2009-0010

125 Auburn St.

CVS Expansion

Northgate Plaza

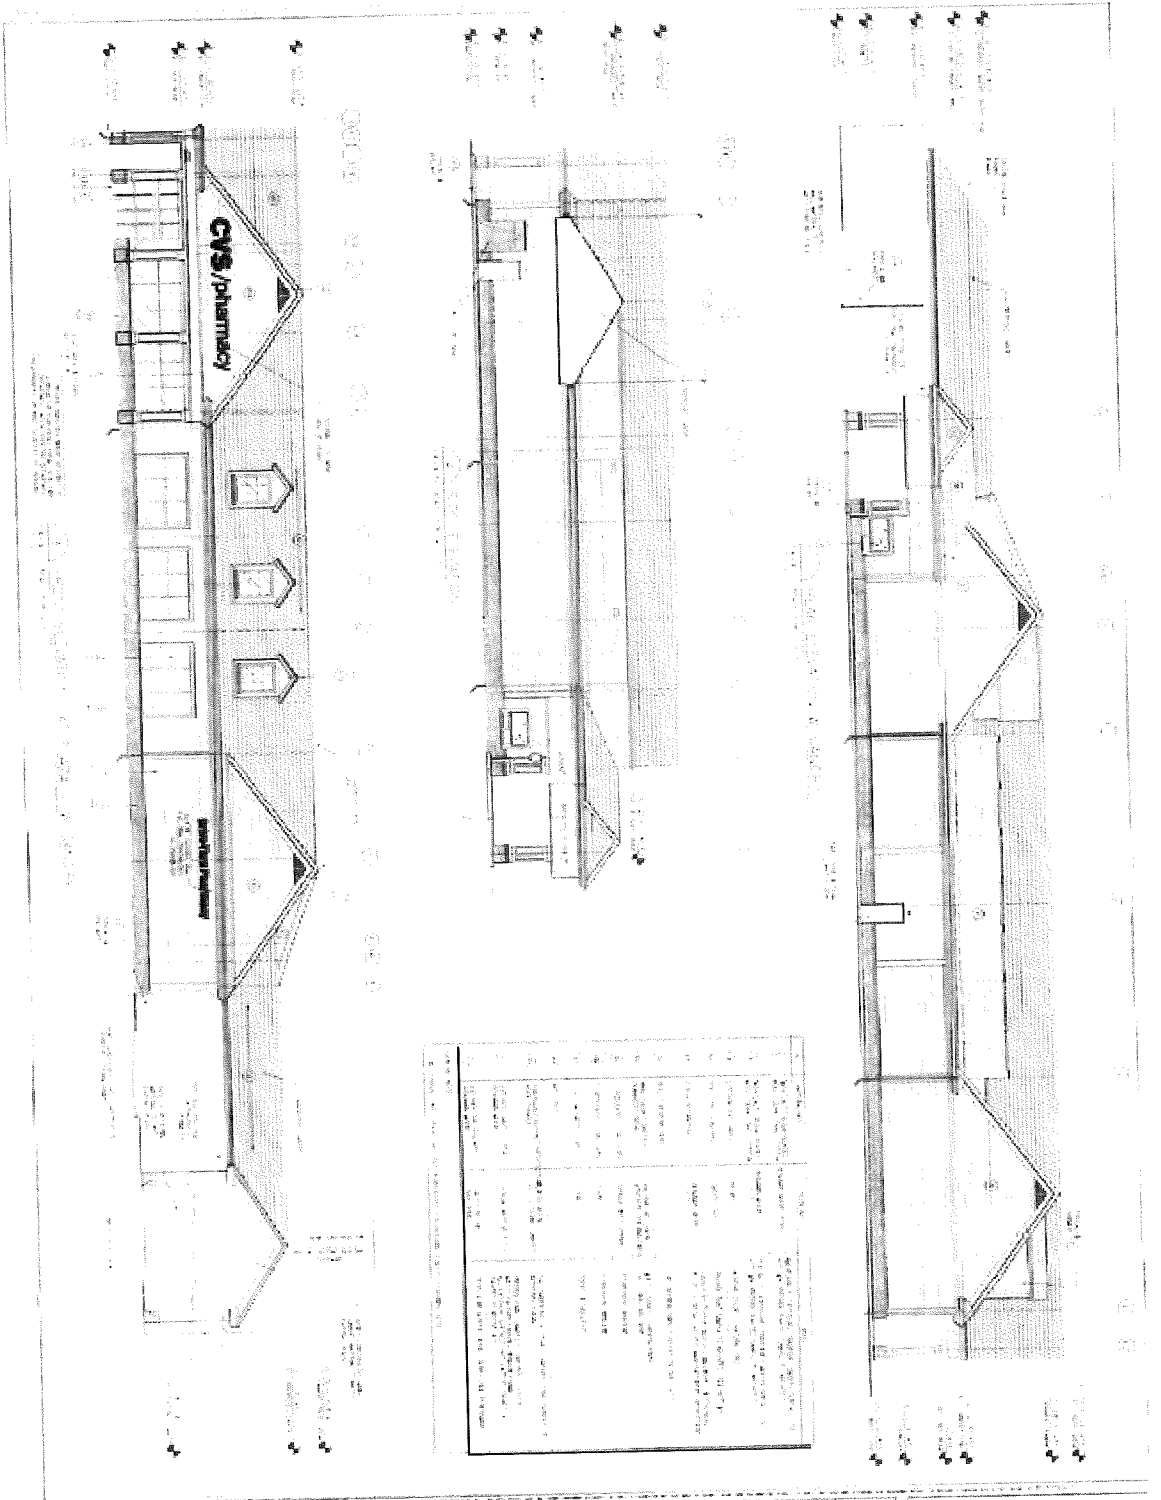
I attach a picture of the width I am referring to.

Could you please ask the architect or the contractor to let me have the actual dimension (as built) between the wall of the CVS facing the drive thru and the 2 columns nearest that edge ie I would like to know the exact width of the space between the wall and the nearest part of the columns facing the wall.

DRIVE-THRU / CROSSWALK
 1 OF 1

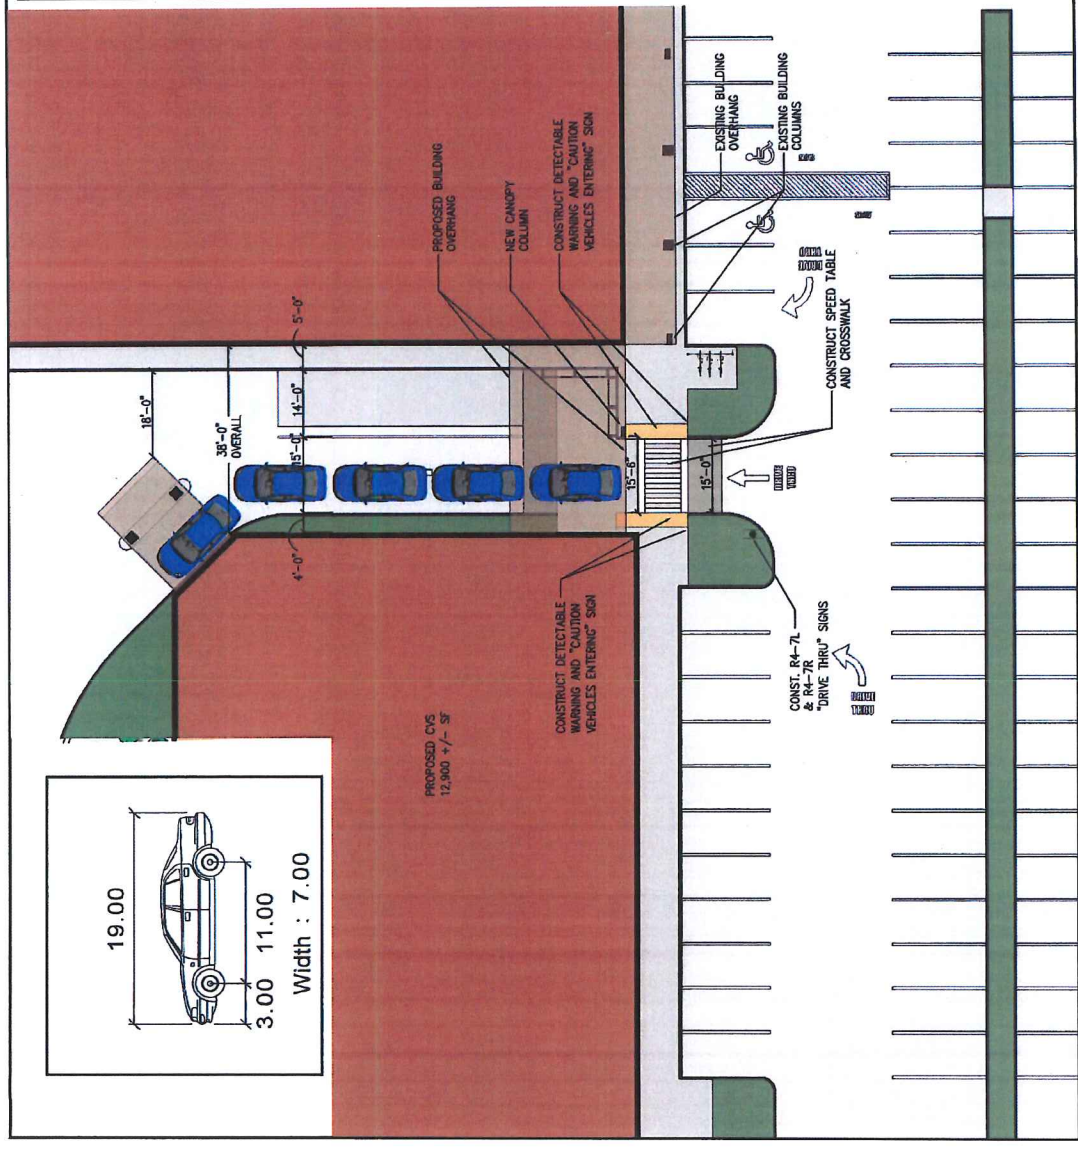
The approved site plan indicates a clear width of 42'-0" between the existing plaza and the new CVS/pharmacy as shown on sheet 1 of 2. This space is comprised of a 6'-0" wide sidewalk along the existing plaza, a 16'-0" wide truck loading area, a 15'-0" wide vehicular driveway, and a 5'-0" wide buffer along the CVS wall.

The proposed plan sheet 2 of 2 reflects the built condition of 38'-0" clear between the two buildings. The sidewalk along the plaza was reduced to 5'-0" wide, the truck loading area was reduced to 14'-0" wide, the 15'-0" driveway was maintained and the 5'-0" buffer along CVS was reduced to 4'-0" wide.

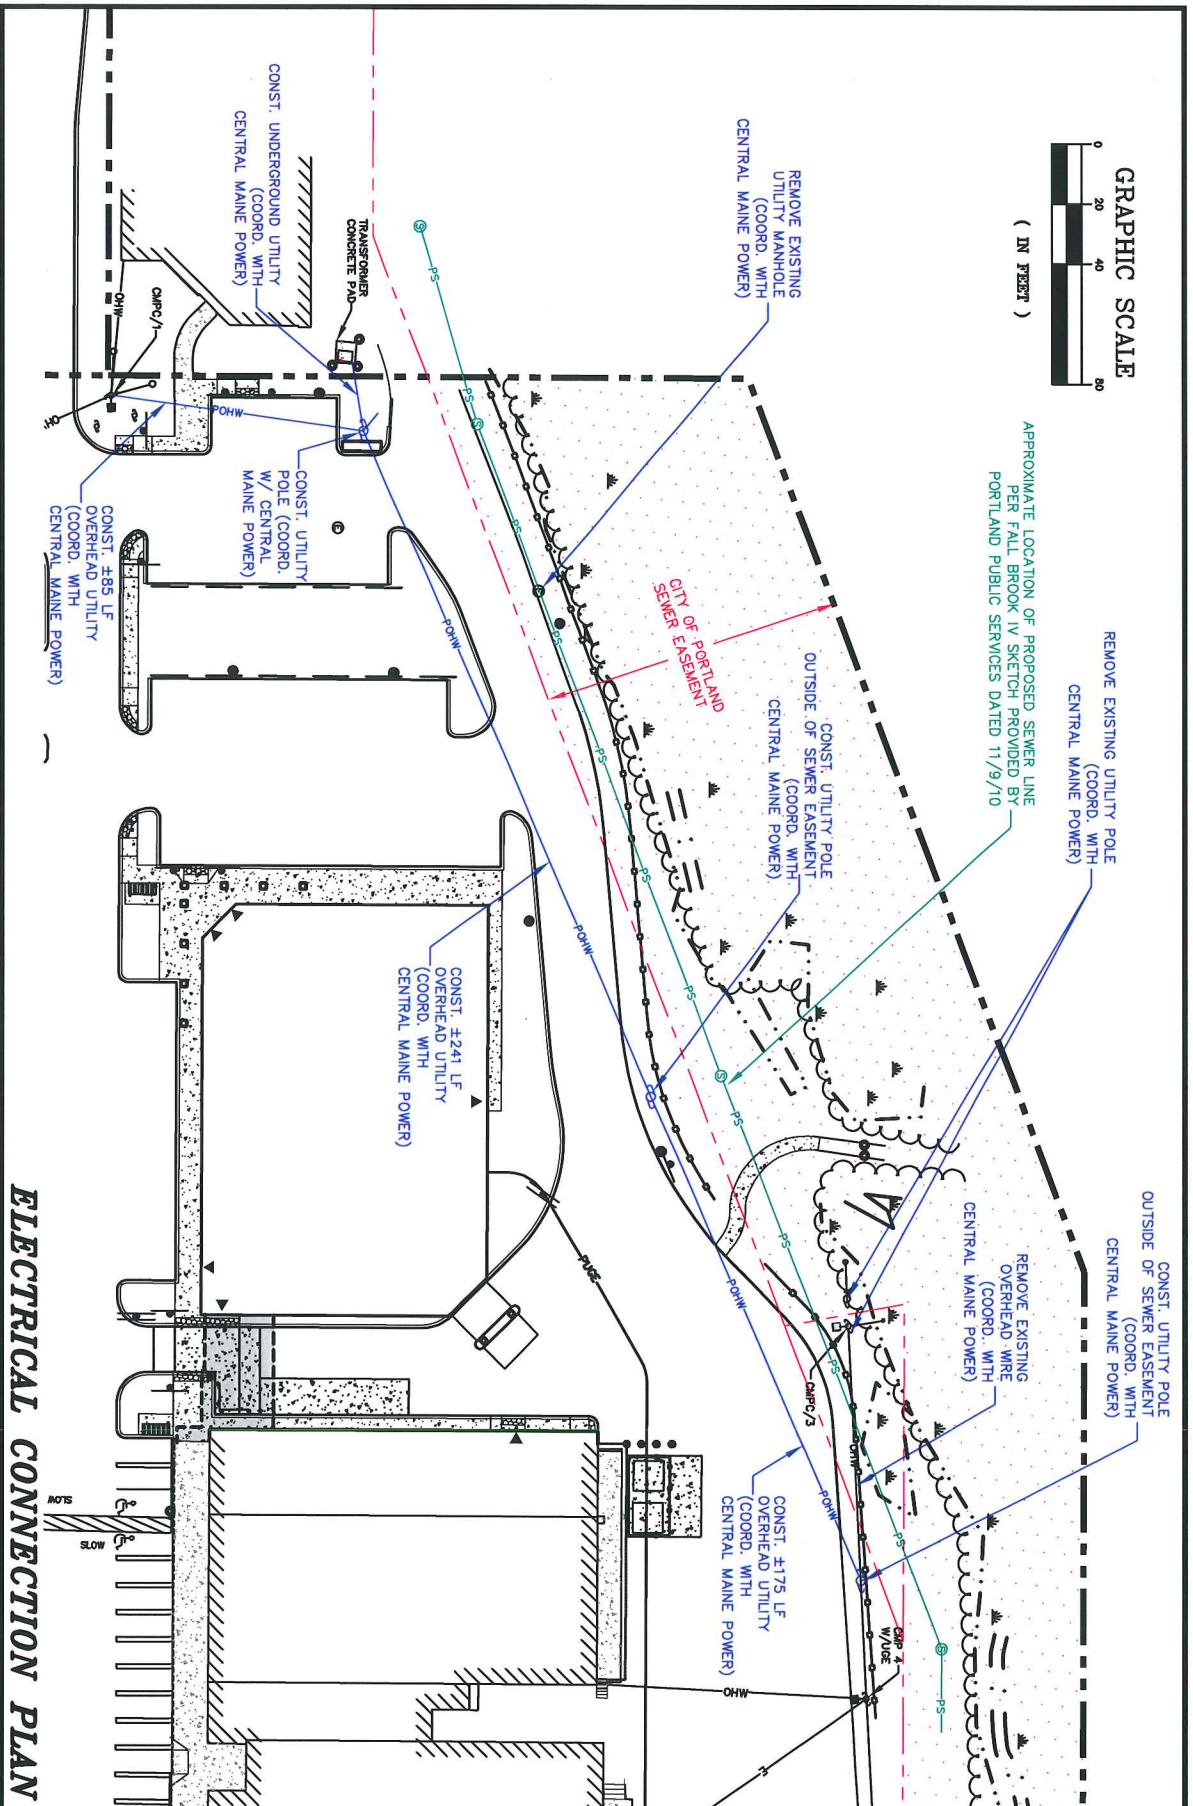
a. Frank to investigate and get advice and let Nathaniel know whether the CMP line was going to be relocated or whether he wanted to hammer out a way for the servicing/drive thru access to be maintained during the Separation Project contract next winter. I suspect he will not want to expend another \$60,000 plus trenching/conduit costs plus another manhole to relocate the CMP line and will ask for more details of how the project would affect access (and snow removal operations I guess).

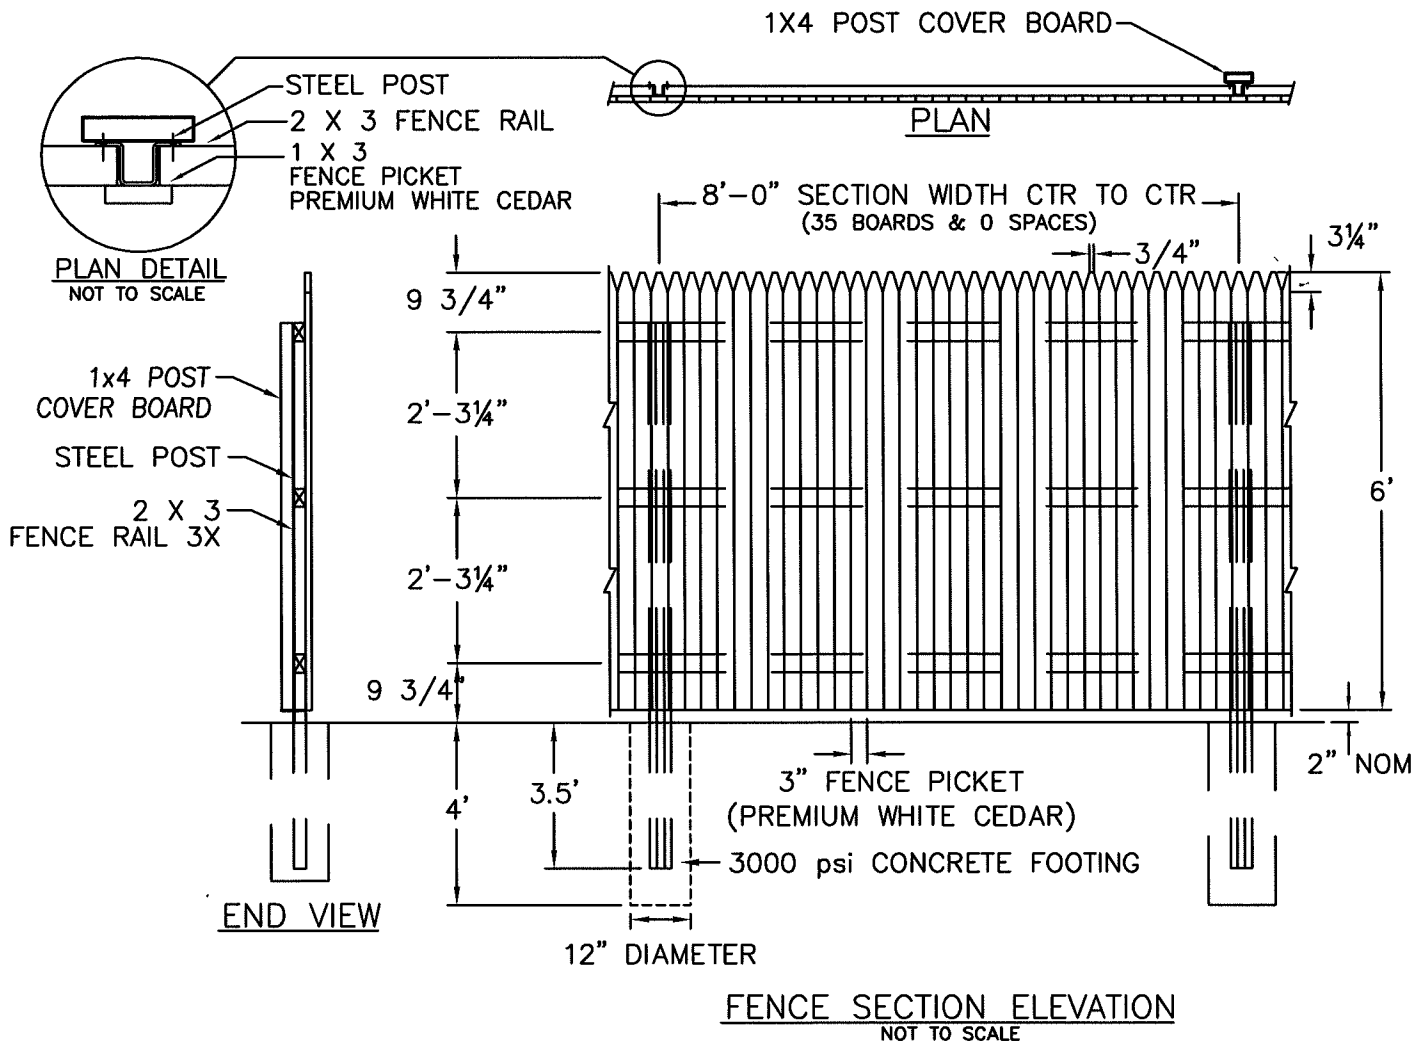
Jean, attached please find a revised detail for the fencing at the rear of the property. Frank indicated that you wanted to see a standard stockade fence. If the detail is acceptable, we will incorporate the detail into our drawing set and issue the final sets for your approval. Frank may be going to Portland again on Thursday, so if we can get approval quickly, we can have the sets hand delivered to you this week. Thanks for the help.
